APPROVALS	DATE	TITLE SERVICE BULLETIN, WSB RT-138-3 (ATTENUATING RECEIVER SENSITIVITY)				
DRAWN Bill Patt	2/15/00					
CHECKED Cliff Estes	2/15/00	SIZE A	CAGE CODE 1B7G3	DWG. NO. 150-040595	REV A	
ENGINEER Steve Wagner	2/15/00					
ISSUED Vern Wallace	2/15/00	SCALE NONE				SHEET 1 OF 1

SERVICE BULLETIN

BULLETIN NUMBER: WSB RT-138-3 Revision A

This Service Bulletin describes the procedure required to modify the RT-138/RT-138F R/T Board.

Figure 2. R/T PC Board - Solder Side

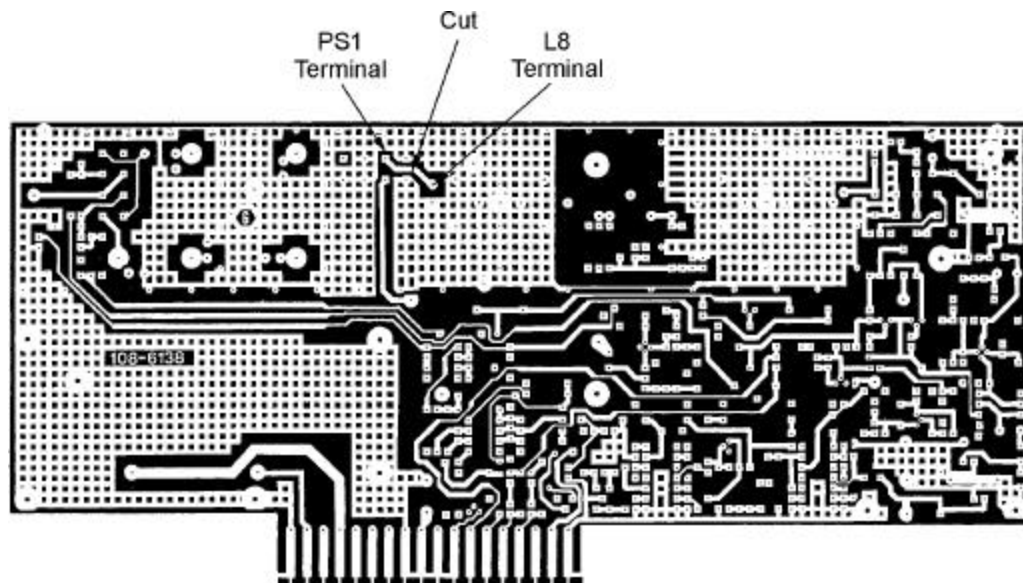
2. Remove the cover from the R/T circuit board.
3. Cut the trace located on the solder side of the board between RF Power Splitter PS1 and Air Coil L8 (refer to Figure 2).

Figure 3. R/T Board Partial Schematic

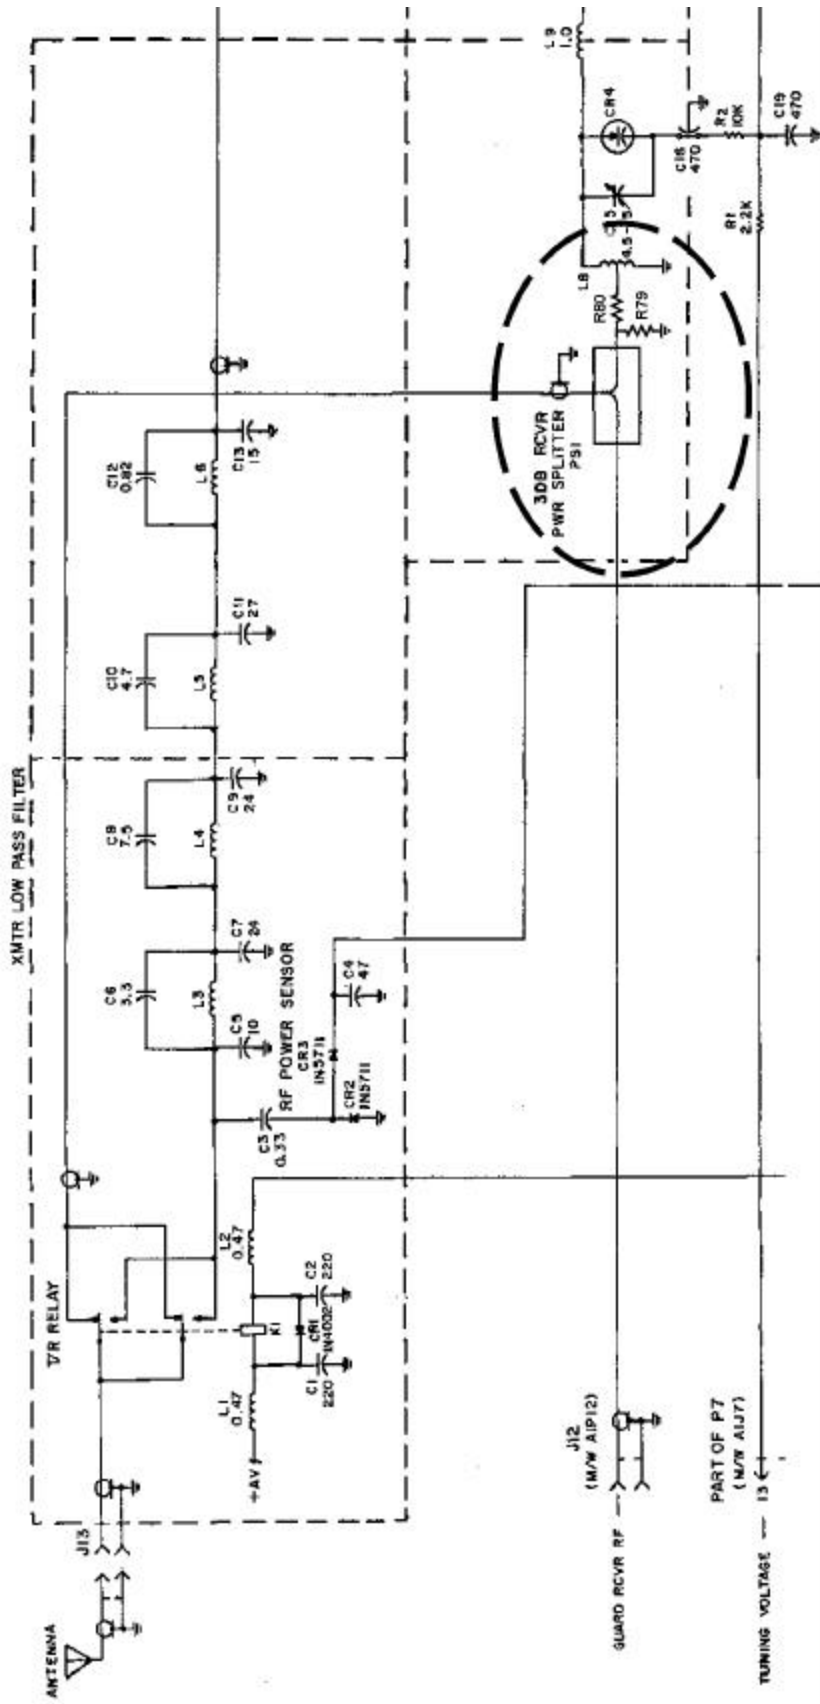
- Install R80 across the cut trace (refer to Figure 3).
- Install R79 between R80 and PS1 (refer to Figure 3). Ground the other end of R79.
- Replace the cover on the R/T circuit board.
- Reinstall the R/T Module and reassemble the RT-138/RT-138F.
